***Urgent Field Safety Notice for:
Dako Autostainer Instruments (AS480; AS100; S3800; S3400):***

Update of Autostainer Link Basic User Guide to reduce risks of staining issues due to leakage

“Instrument leakage inspection

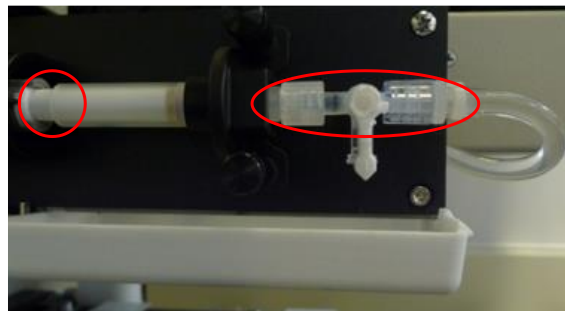
- **New section below has been added regarding inspecting the instrument for signs of leakage** (Table in “Cleaning and Maintenance Guideline Summary”, in English version: page 182, and in subsection “Instrument Leakage Inspection”, start of subsection in English version: page 188)

Visually Inspect the left plate, and the area around the wash station for salt residues and/or liquid, see pictures below. If there are signs of unexpected salt residues and/or liquid, contact your local Agilent Technical Service representative as this might indicate a leakage in the liquid system. If leakage is observed, the slides from the run just completed must be closely reviewed for staining abnormalities.”

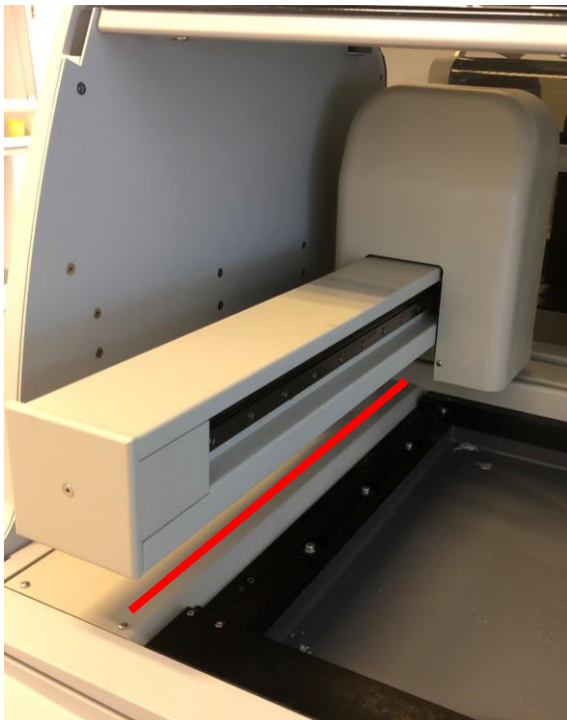
Visually inspect the syringe tray, syringe and stopcock, areas highlighted in red, for signs of unexpected leakage (salt residues and/or liquid).

Visually inspect the left plate, area highlighted in red, for signs of unexpected leakage (salt residues and/or liquid). This might indicate leakage from the robotic arm.

Visually inspect the area around the wash station, area highlighted in red, for signs of unexpected leakage (salt residues and/or liquid). This might indicate leakage from the z-head or too high pump pressure.
